MEMO

From: Brian Watson, PE, PH, D.WRE, Tetra Tech
Marcy Frick, REM, Tetra Tech
Jim Greenfield, PE, Tetra Tech
Nikolai Gurdian, Tetra Tech
Erin Lincoln, PH, Tetra Tech
Scott Wuitschick, AMEC

Subject: Caloosahatchee River Basin Watershed Model Review and Calibration Refinement –
Final Task 1 Findings and Recommendations

Figure 4: Reaches with bidirectional flow due to agricultural and flood protection pumping

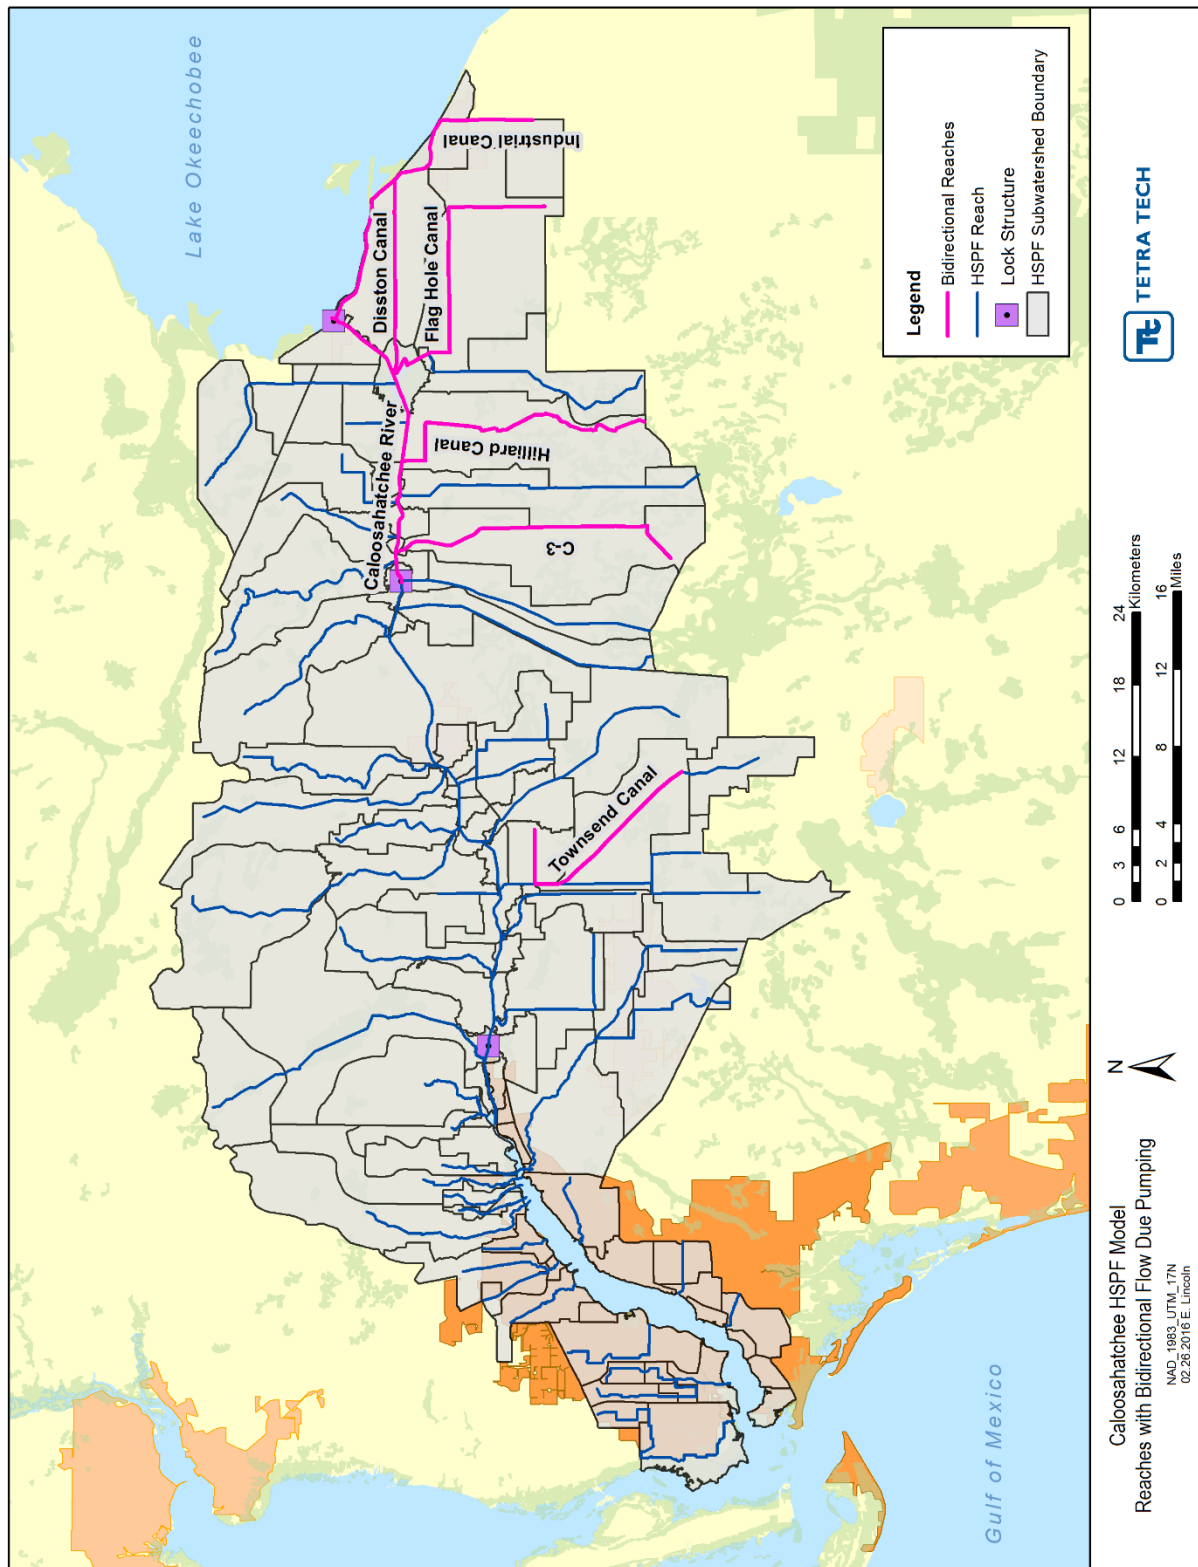
The HSPF model cannot represent bidirectional flow, and the 2009 and 2014 HSPF Models did not explicitly represent the bidirectional flow in the watershed reaches. In the models, the reaches were assumed to be one-directional towards the Caloosahatchee River. The F-Tables represented the net positive flows to the Caloosahatchee River. In addition, there are no pumping records available that provide information as to the timing and volume of water moved through the canal systems. Tetra Tech will assume that pumping is occurring when farmers need water for irrigation, and that the volume of water pumped upstream in each canal is directly related to crop irrigation. Tetra Tech has provided several recommendations for representing the bidirectional flows in both the agricultural and tidal reaches in **Section 2.6**.

Issue #3: (*Stakeholder comment*) There are priority reaches within the Caloosahatchee Basin with bidirectional flow. The bidirectional flow was not adequately modeled in the 2009 and 2014 models.

Recommendation: Seven canals have been preliminarily identified as having bidirectional flow caused by agricultural irrigation, and Tetra Tech and the department will evaluate the best method to represent bidirectional flow in the watershed model. Tetra Tech has identified two potential methodologies to represent the agricultural canal bidirectional flows, as described below. The methodologies can be used in combination, or a different methodology can be used, as appropriate.

Method 1: Tetra Tech will overlay an EFDC model on impaired reaches with bidirectional flow (Townsend Canal and Caloosahatchee River). The HSPF model will provide watershed flows (surface, interflow, and ground water) and water quality loadings (PQUAL/IQUAL concentrations) to the EFDC model. The PQUAL/IQUAL constituent fractionation shown in **Table 2** will be used to deliver the nutrient concentrations to the EFDC model. The EFDC model will be used to simulate the hydrodynamics and in-stream water quality of the impaired reaches.

Method 2: Tetra Tech will use a targeted withdrawal setup to simulate the bidirectional flow in HSPF reaches with bidirectional flow caused by agricultural irrigation. Tetra Tech will determine the timing and quantity of surface water needed in each subbasin to satisfy agricultural irrigation demands (see Issue #7). Using this information, Tetra Tech will develop a pumping record for the canals that is directly related to the agricultural irrigation demand. Tetra Tech will withdraw water from the downstream reach of the canal and transfer the water, including the associated water quality concentrations, to the upstream areas of the canal or neighboring subbasins. The targeted withdrawals will mimic the reverse flows that occur in the canals, and approximate the mixing effects associated with the flow reversals and transfers.

Figure 8: Unit area flows by land use for pervious areas

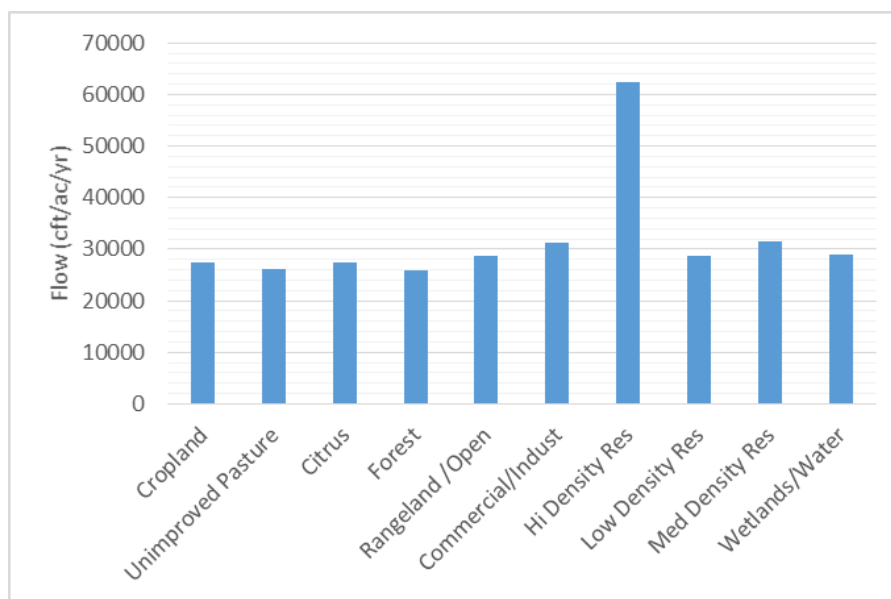
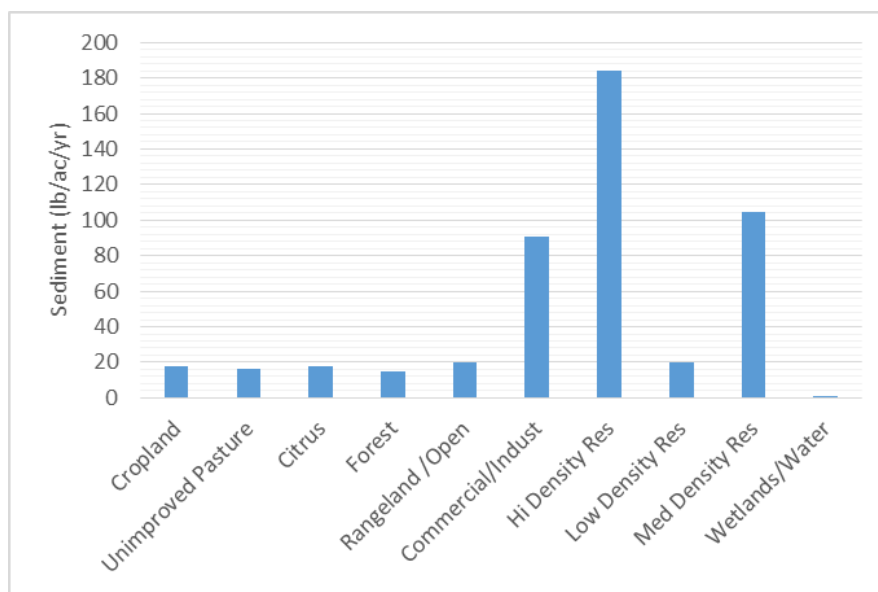
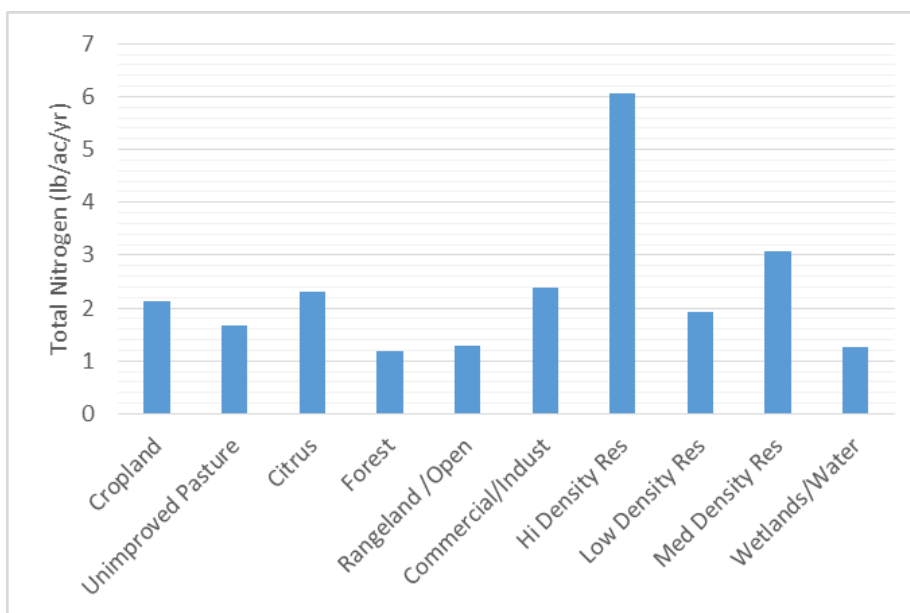
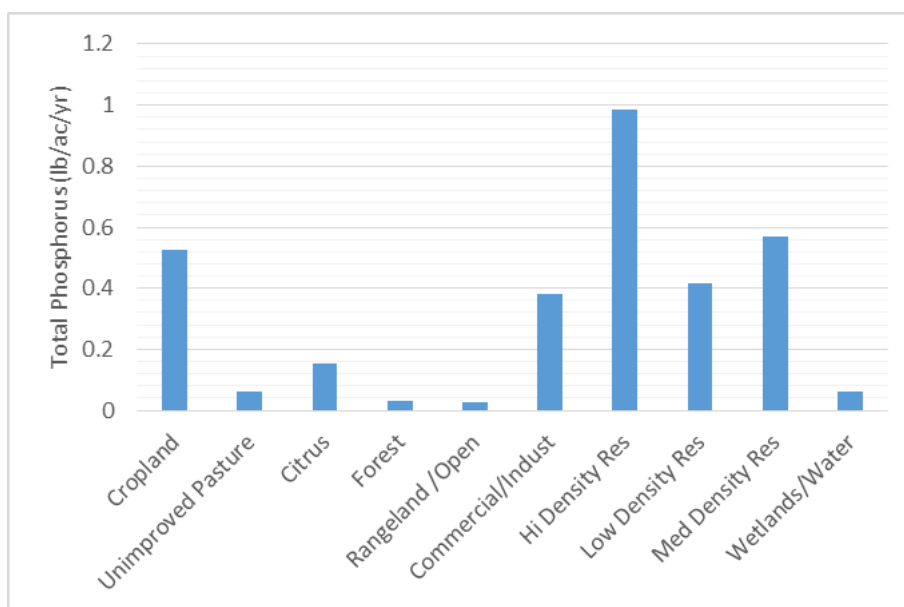
When loads are transferred from the upland simulation to the reach simulation, assumptions are made for disaggregating upland parameters to instream constituents as shown in **Table 2**. The only disaggregation

that is referenced, however, is the relation of ORP to ORN, which is described as being “based on [station] CES01 data” in the model UCI file notes. For the remainder of the modeled pollutants (sediment, organic carbon, and NO_x species) there is no documentation on how the splits were determined. Additional effort may be required to better characterize the disaggregation. It should be noted that BOD entering reaches also implicitly contains labile forms of OrgN, OrgP, and organic carbon determined by ratios set within the RQUAL module. These labile forms are converted to inorganic nitrogen, phosphorus, and carbon when BOD decays. A summary of the unit area pollutant loads for pervious areas from the 2014 Model by model land use are provided in **Figure 8** through **Figure 11**. These unit area loads are calculated from the HSPF model output, and the model was not forced to match any literature values.

Figure 18: Caloosahatchee EFDC bottom elevations

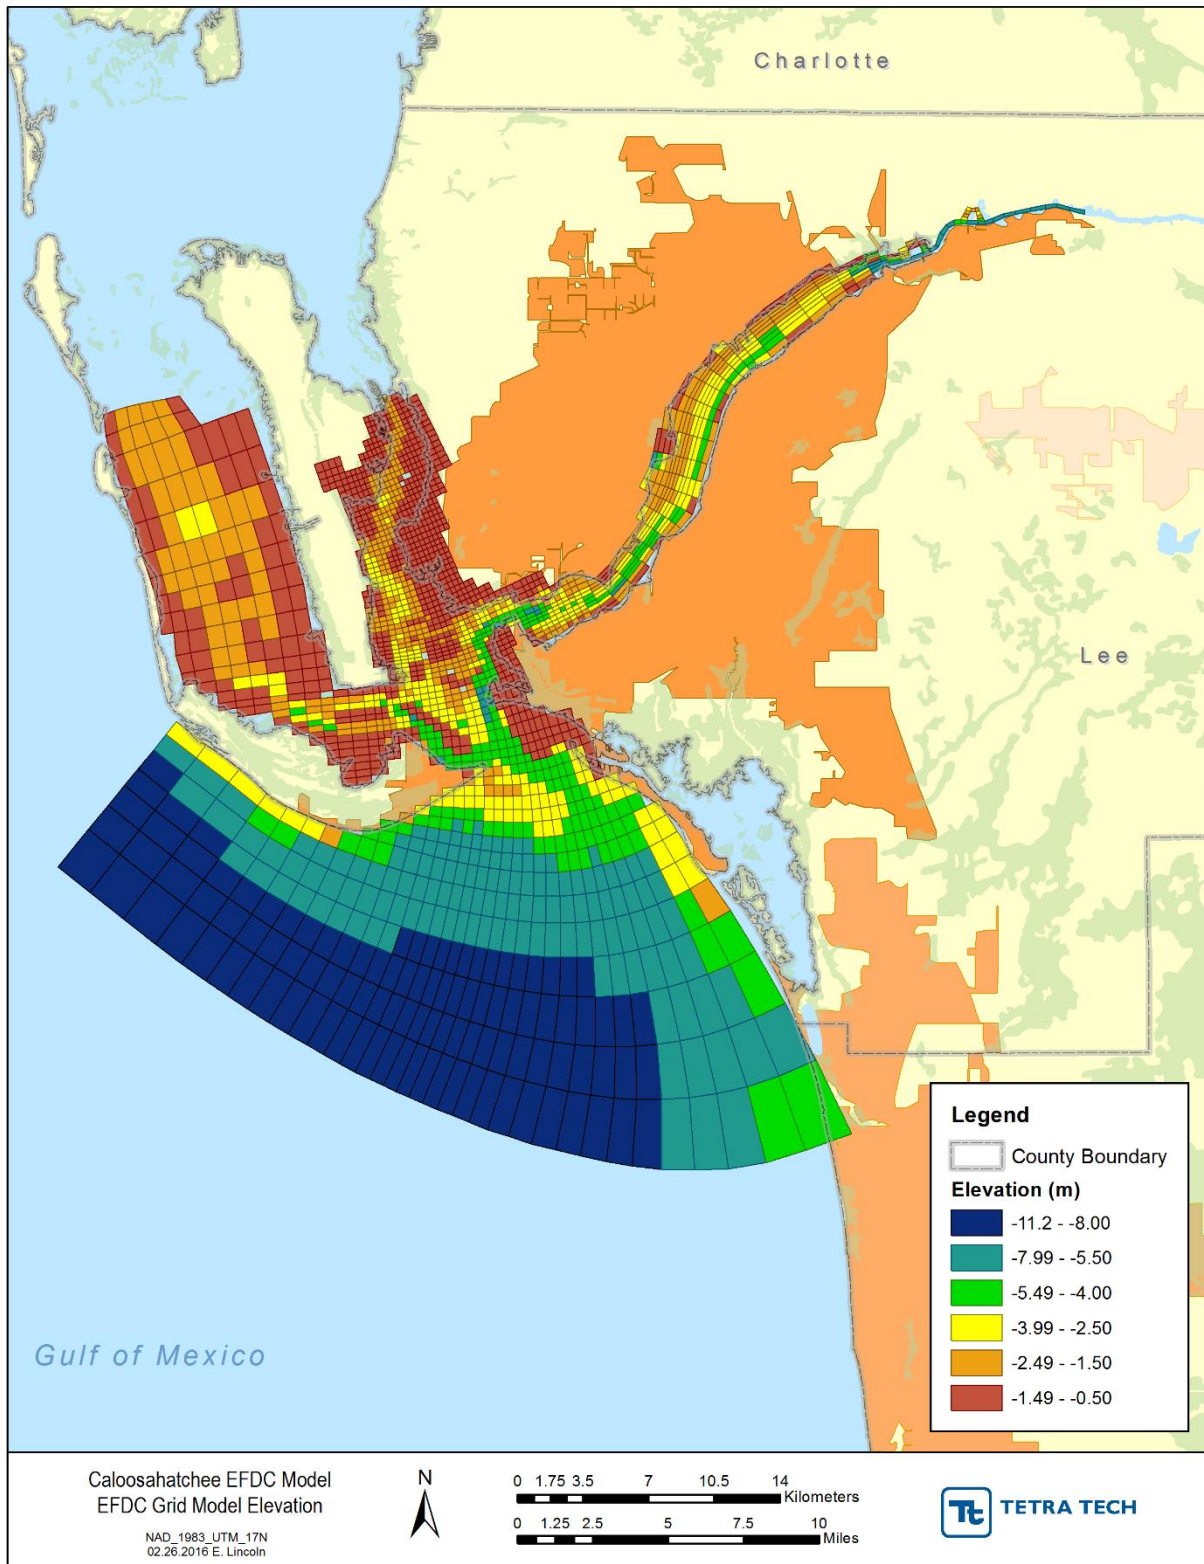
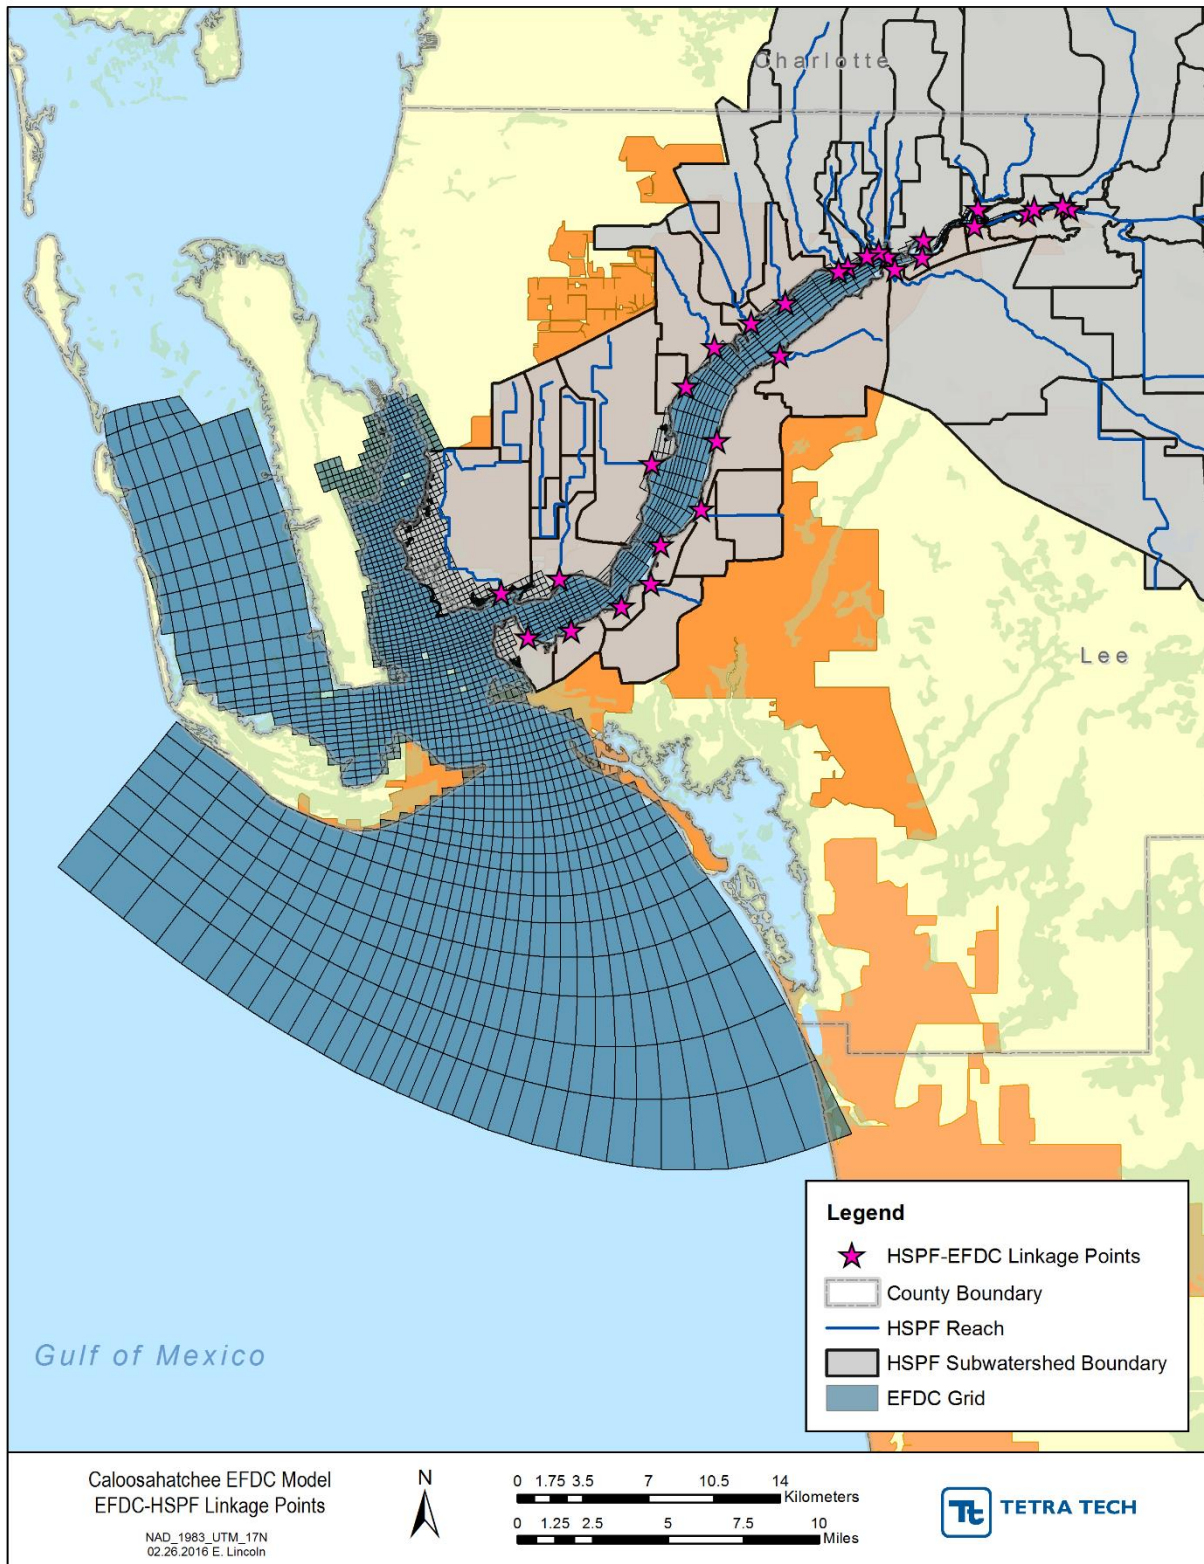
The marsh areas, as represented in the current grid, are much deeper than the depths indicated on the NOAA nautical charts. Most likely, the routine used to set the various grid depths used the marsh channels' contour lines to assign depths for the entire marsh area, which resulted in marsh area depths of 1 to 2.5 meters. Tetra Tech recommends that the depths for the areas that are salt marshes be capped at a maximum depth of 0.5 meters, with the appropriate vegetation settings.

The original bathymetry appears to be from online NOAA depth data and should be adequate for this project. However, these data need to be checked against NOAA nautical charts to ensure the data are translated to the model grid correctly (**Figure 18**).
